StatGPT

Exploring Official Statistics using Generative AI and SDMX

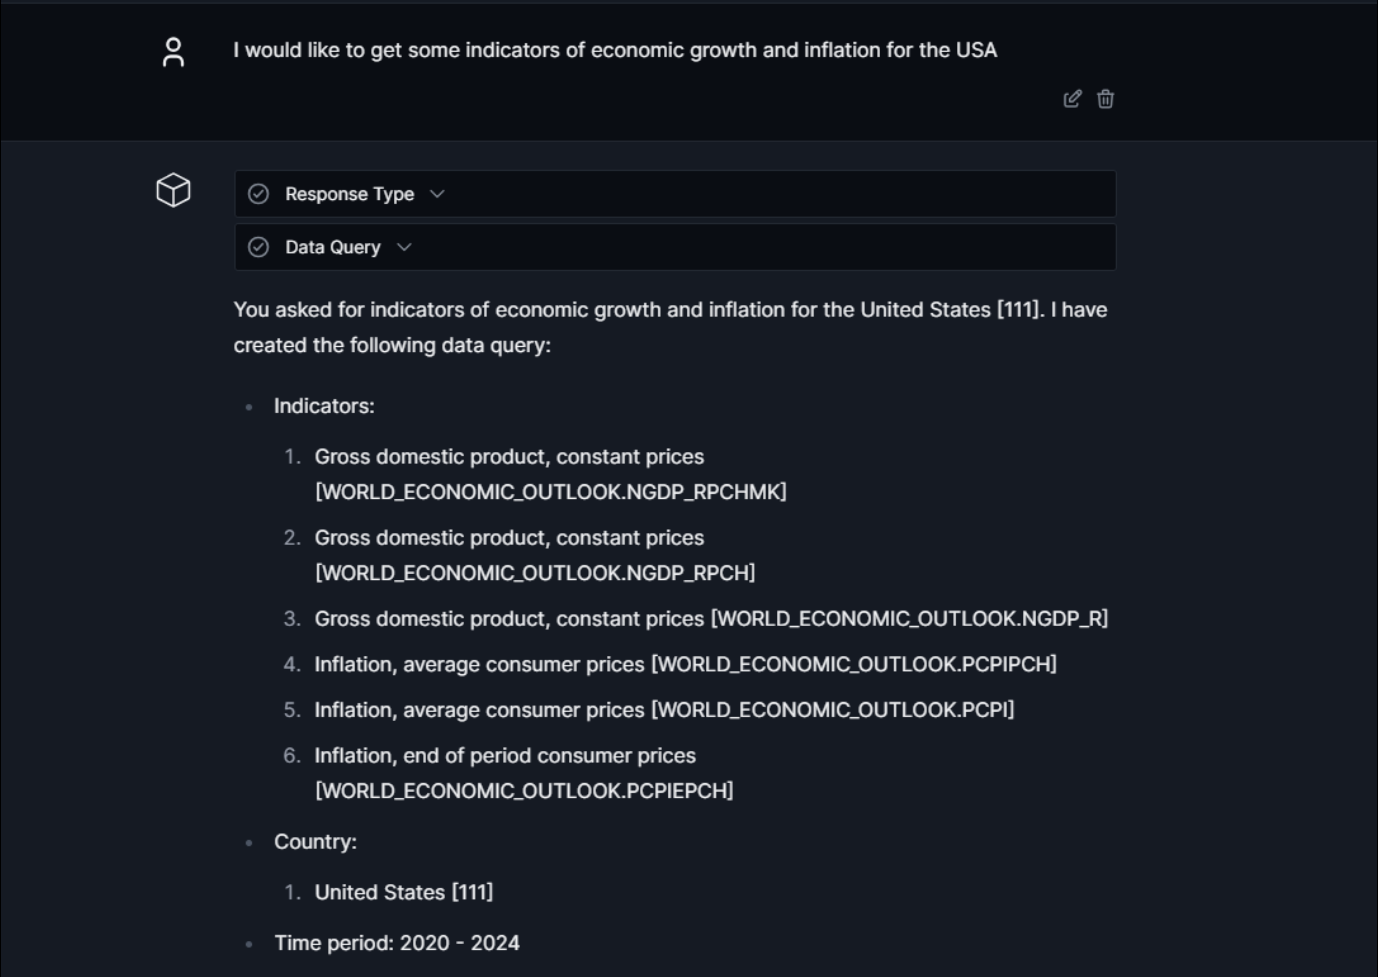
The screenshot displays the StatGPT application interface. At the top, a user profile icon is followed by the query: "I would like to get some indicators of economic growth and inflation for the USA". To the right of the query are icons for editing and deleting. Below the query, there are two dropdown menus: "Response Type" and "Data Query". The main content area shows the system's response: "You asked for indicators of economic growth and inflation for the United States [111]. I have created the following data query:". This response is structured into three categories: "Indicators:", "Country:", and "Time period:".
